Appendix 6 Further Information and third party responses to concerns raised regarding the Proposed Lyrenacarriga WF, Counties Cork and Waterford

Author: Annette Quinn

Date: 01/07/2022

Tobar Archaeological Services Ltd prepared the archaeology and cultural heritage chapter of the EIAR which accompanied the planning application for a proposed wind farm at Lyrenacarriga, Counties Waterford and Cork. This document consists of the responses to a request for Further Information (ABP Ref 309121-21 issued by An Bord Pleanála as well as addressing third party concerns.

Plate 1-1: Aerial View of Kilmore House (also presented in the RFI LVIA Report)

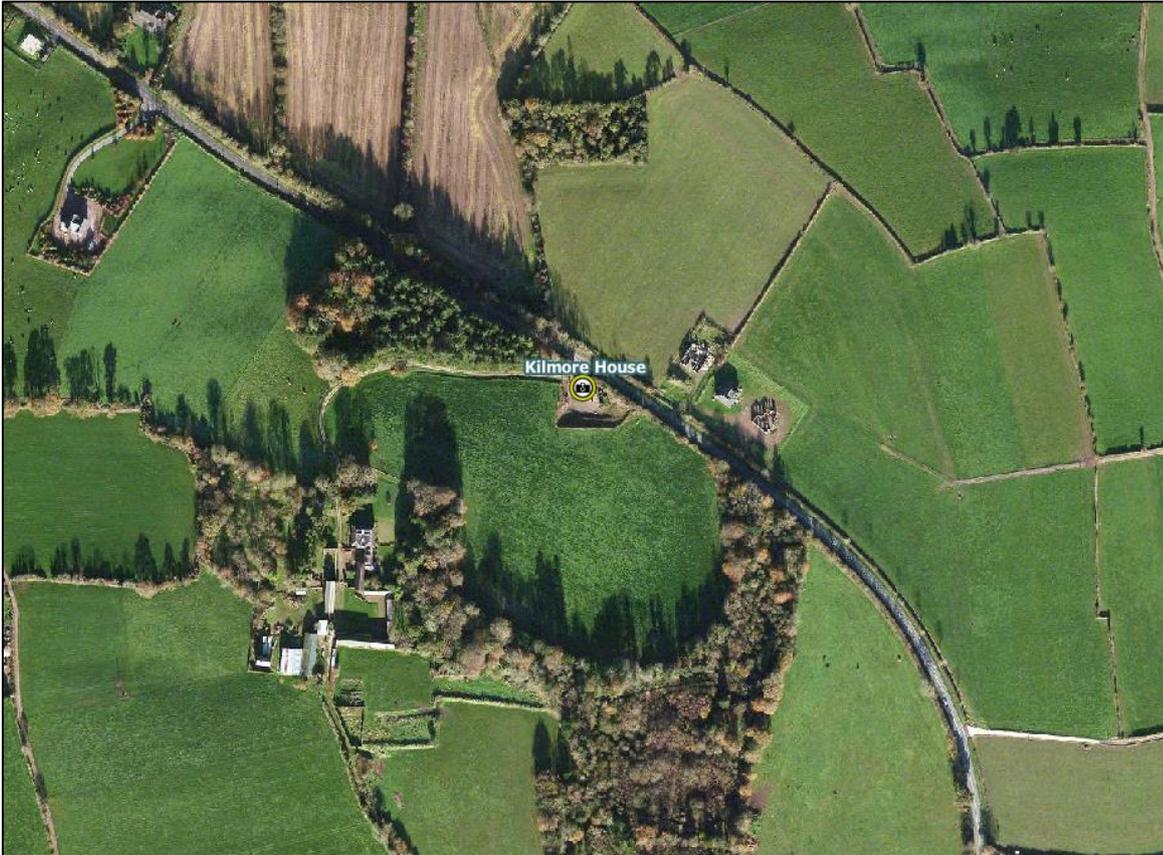
The site of the house itself is not accessible to the public and access could not be obtained during the site visit. Similar to the above, this site is located on the edge of the ZTV and therefore visibility is limited even where there is open visibility in the direction of the Proposed Development. **Error! Reference source not found.** below is an aerial view of Kilmore House, showing a large area of woodland surrounding the site. With the direction of the Proposed Development to the south, it is clear from the aerial imagery that there will be limited to no visibility of the Proposed Development from this site, as a result of screening from the vegetation (deciduous woodland) and the fact that there is already likely limited visibility indicated on the ZTV. The overall effects will therefore be imperceptible. This structure is also discussed further in Section 1.2.2 of the RFI LVIA Report.
